Well Name: LOBO 33/28 B3OB FED COM	Well Location: T21S / R32E / SEC 33 / SWSE / 32.4283577 / -103.6769495	County or Parish/State: LEA / NM
Well Number: 1H	Type of Well: OIL WELL	Allottee or Tribe Name:
Lease Number: NMNM086710	Unit or CA Name:	Unit or CA Number:
US Well Number:	Operator: MEWBOURNE OIL COMPANY

Notice of Intent

Sundry ID: 2797671

PECOS DISTRICT DRILLING CONDITIONS OF APPROVAL

Figure 3. Cactus 9 5/8" 5M offline cementing tool. Pressure rating limited by the lesser of 5M tool rating or the 9 5/8" pup joint and casing.

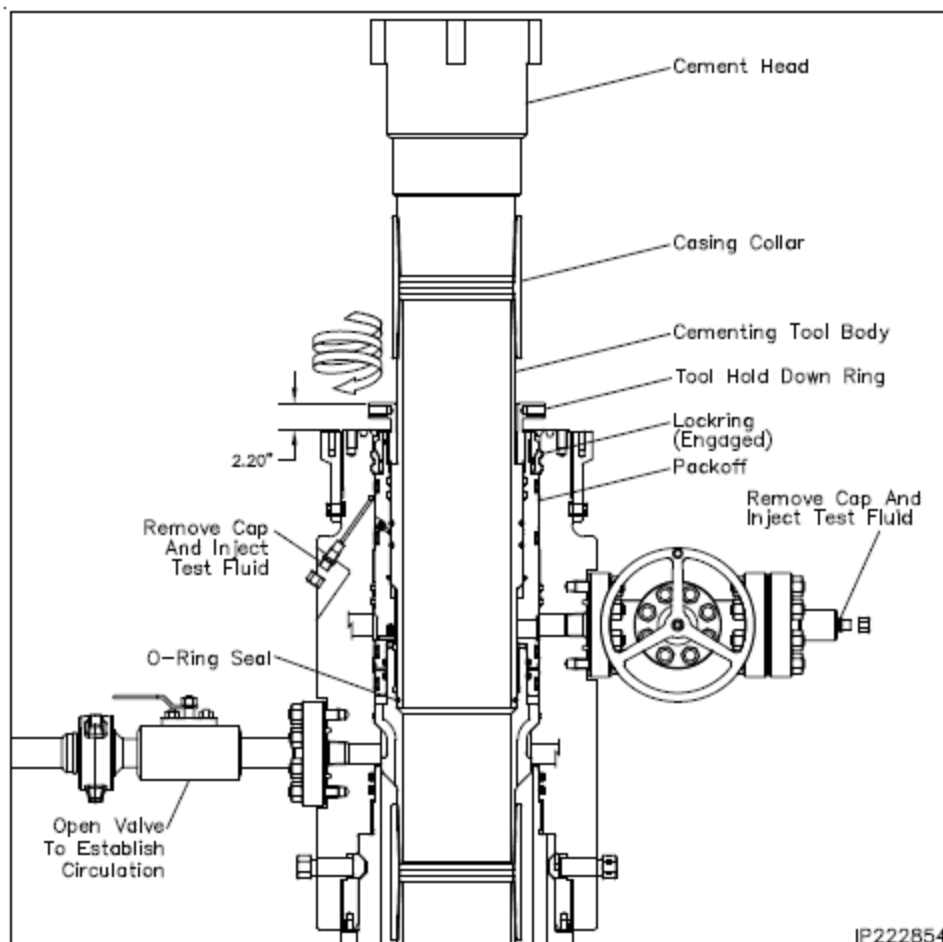
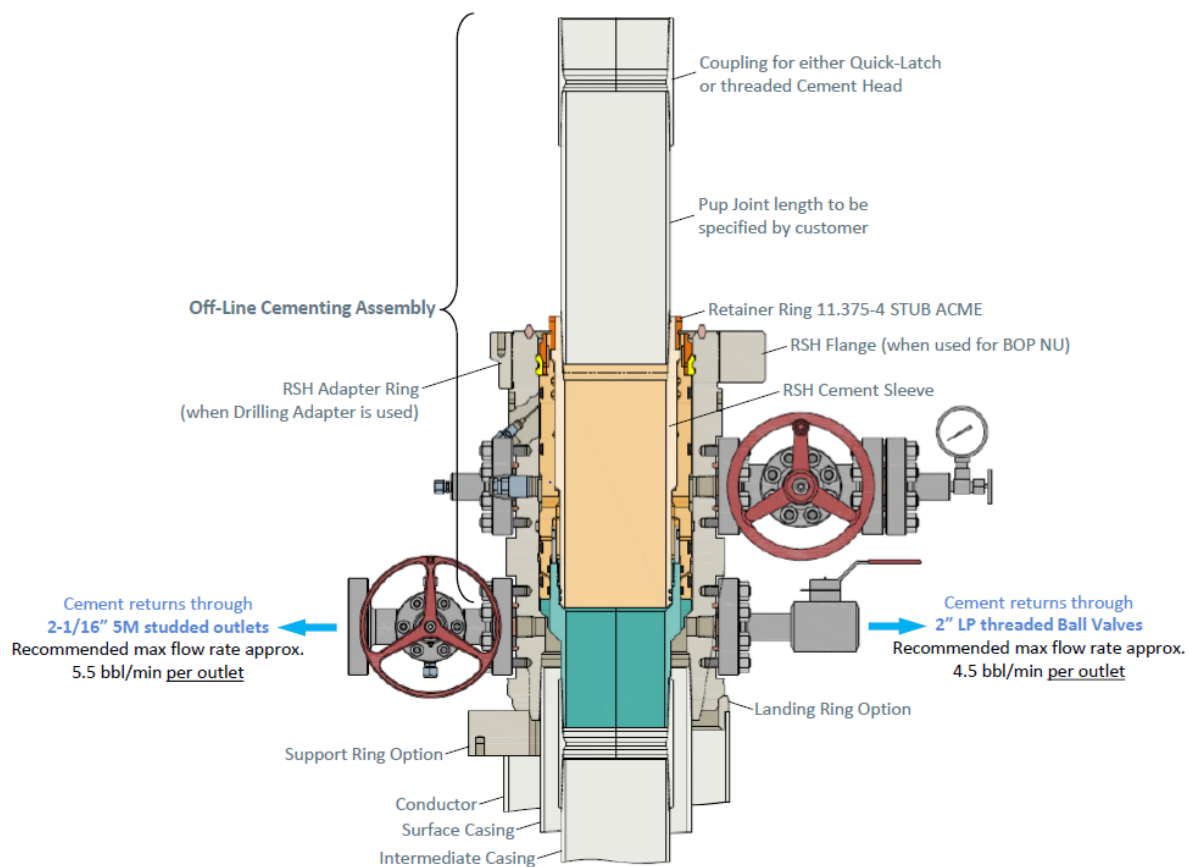
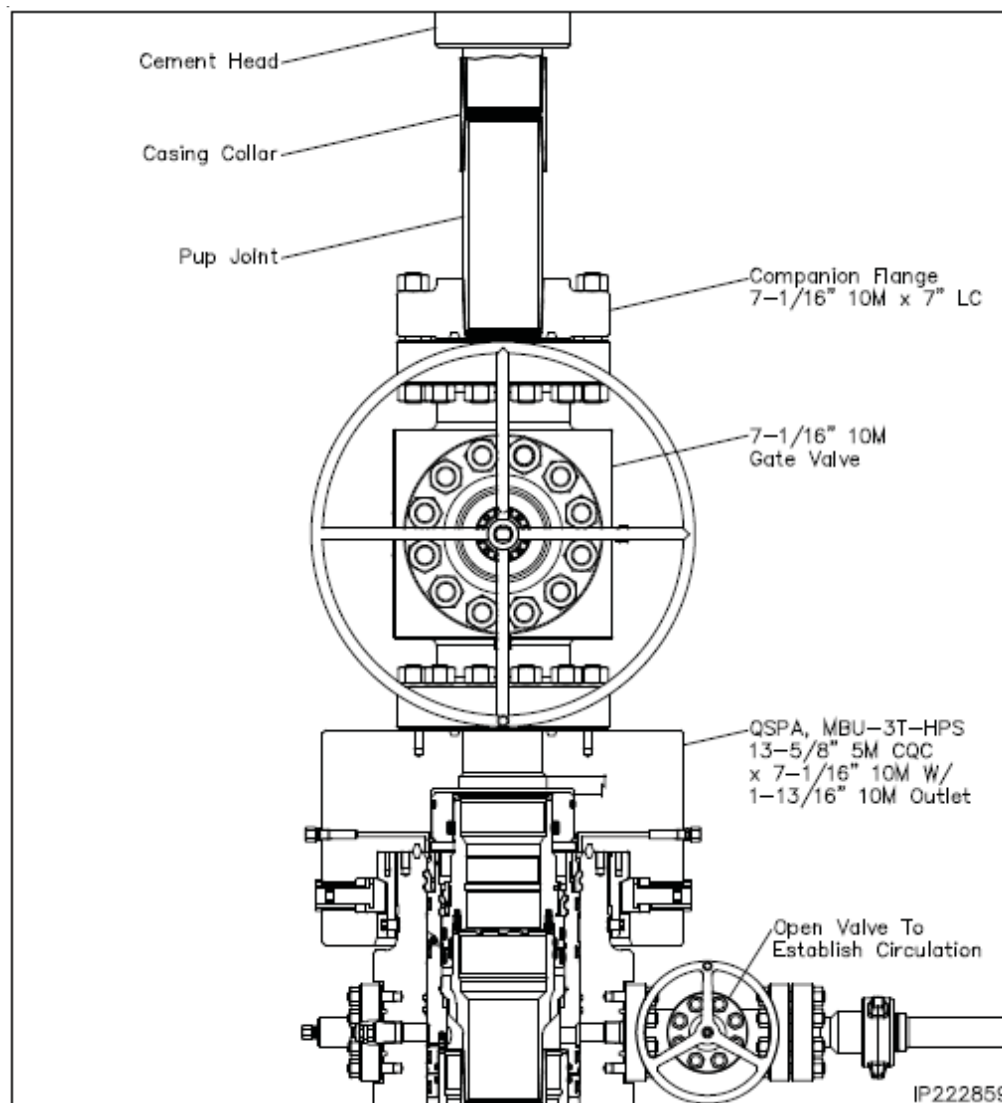
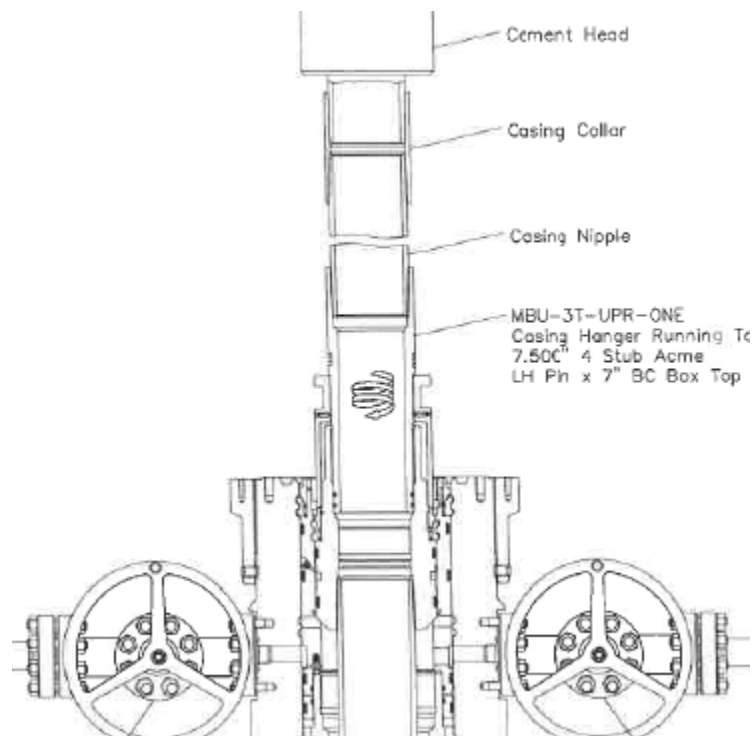
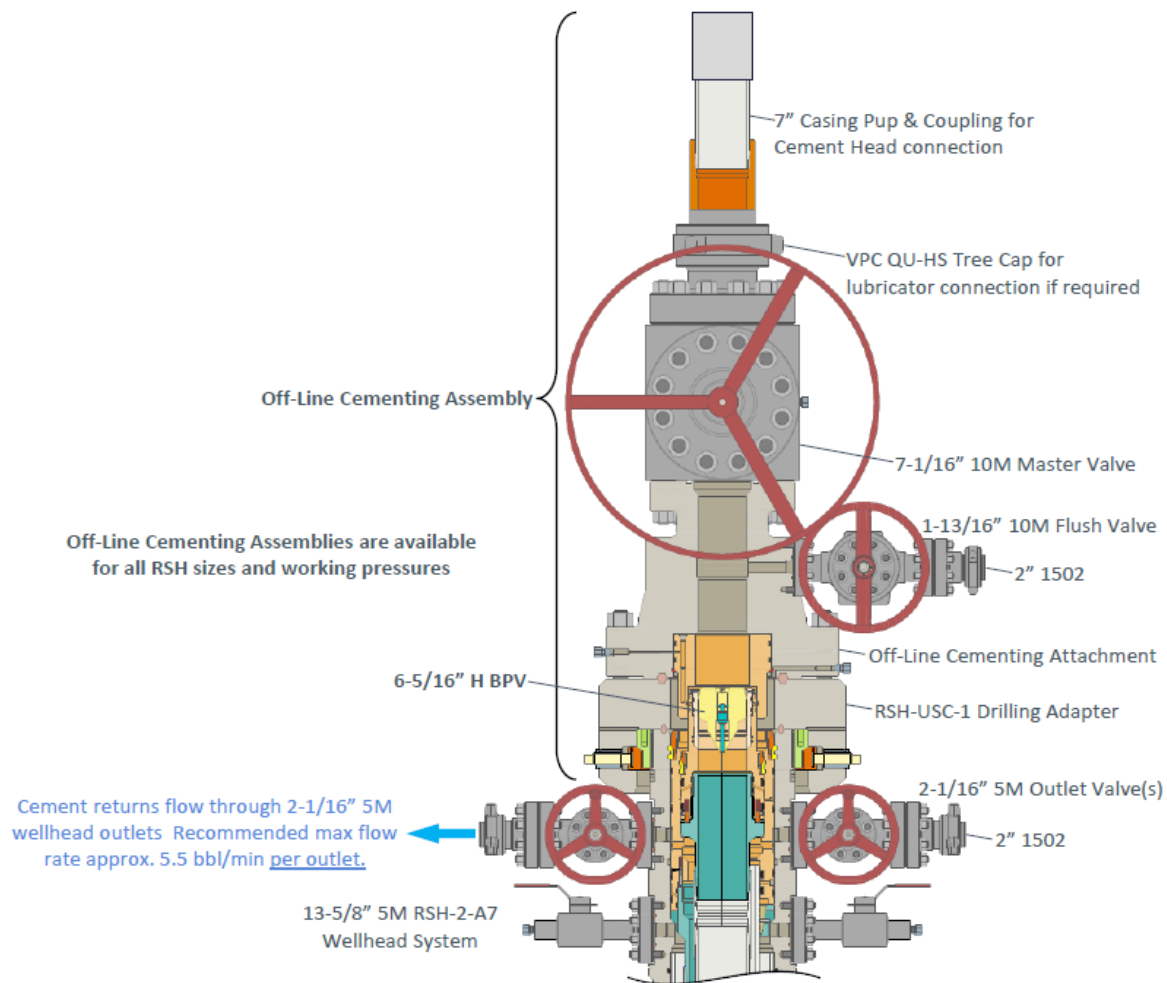
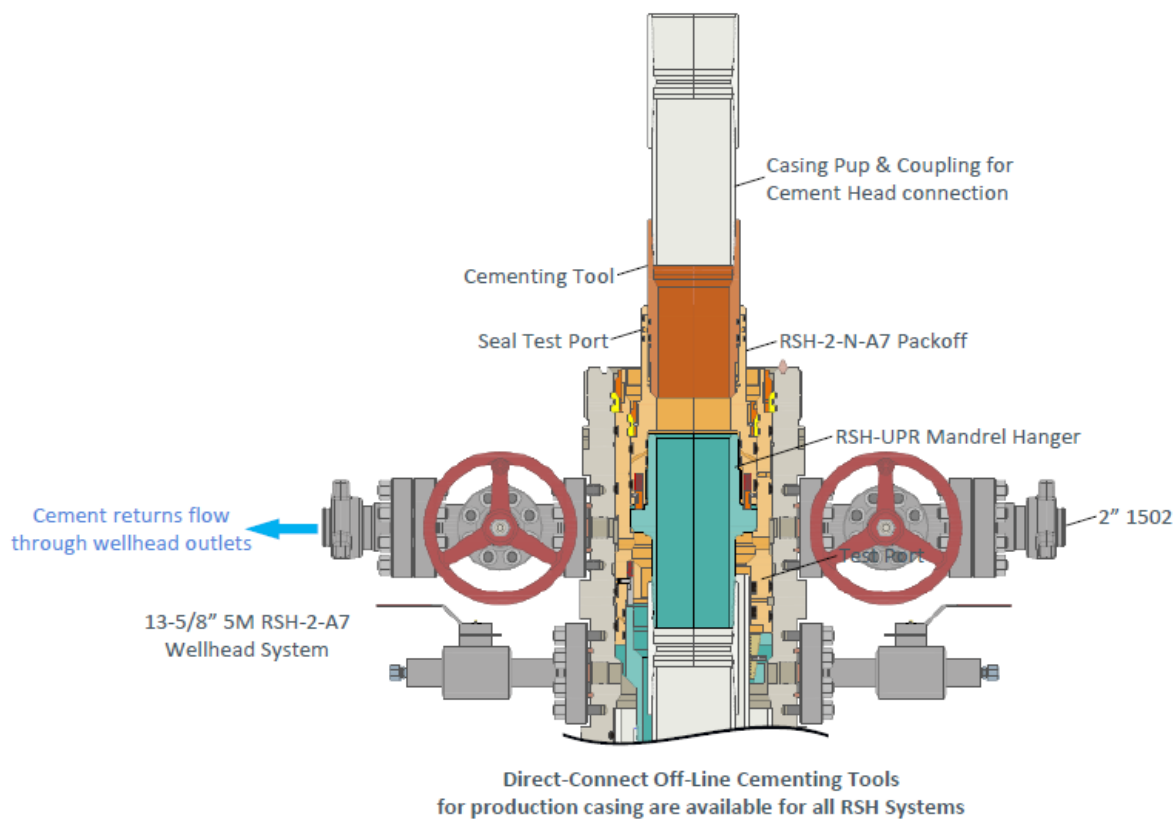
10. Make up offline cement tool using forklift per wellhead manufacturer (Fig. 3 - 8).
11. Make up cement head on top of offline cement tool.
12. Commence cement operations.

Figure 9. Five valve 15k choke manifold.

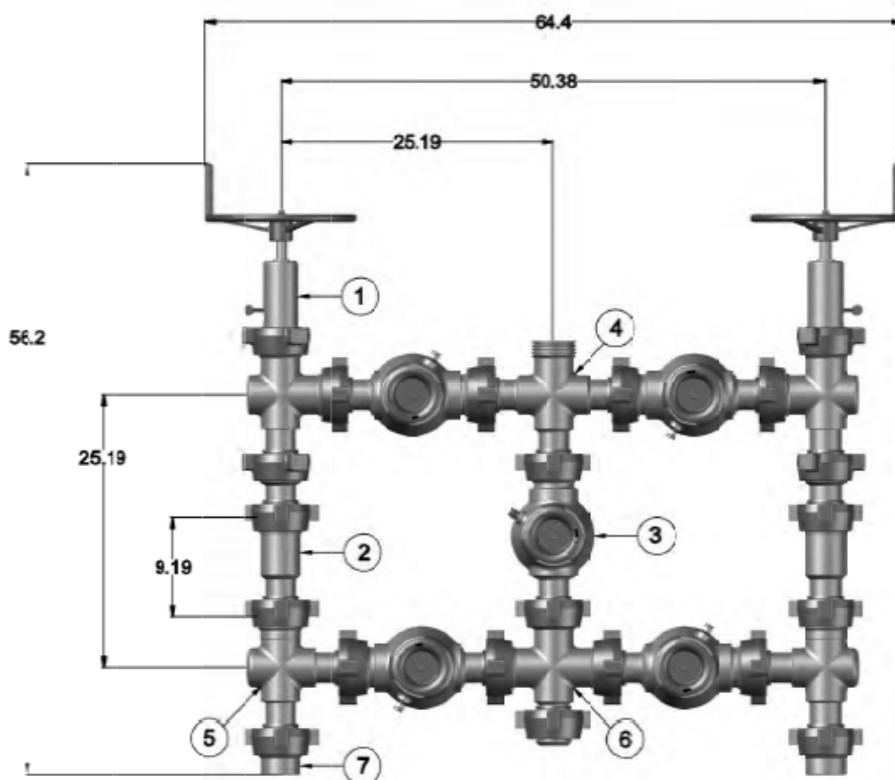
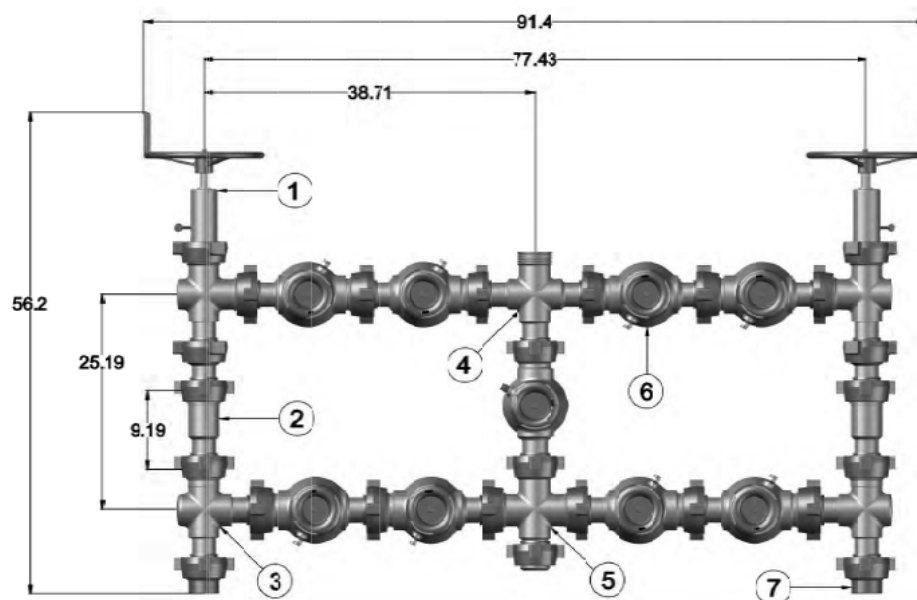
- Pressure build up in annulus before cementing
 - Contact BLM if a well control event occurs.
 - Rig up 3rd party pump or rig pumps to pump down casing and kill well.
 - Returns will be taken through the wellhead valves to a choke manifold (Fig 9 & 10).
 - Well could also be killed through the wellhead valves down the annulus.
